# Access Compliance Report

## Public Rights-of-Way

Intersection ID: 18541	Main Street: PROVIDENCE_RD	Cross Street: WESTBURY_RD	Location: E
ADA ID: AD34AF74F16E	Ramp Type: PerpDiag	Initial Pass/Fail: Fail	Overall Compliance: No
Severity Score: 8.75			
Codes/Mitigation Info/Possible Solution		Field Measurements/Component Compliance

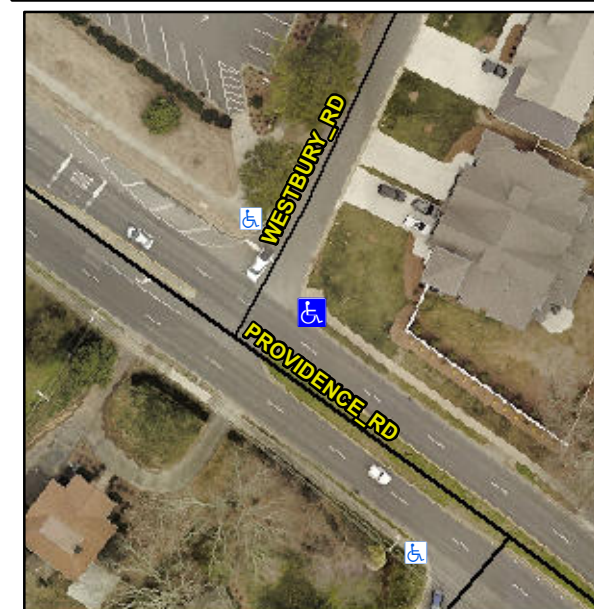
**Remove & Replace Curb Ramp With Two New Directional Ramps or Equivalent.**

**Not Found, R304.5.1**
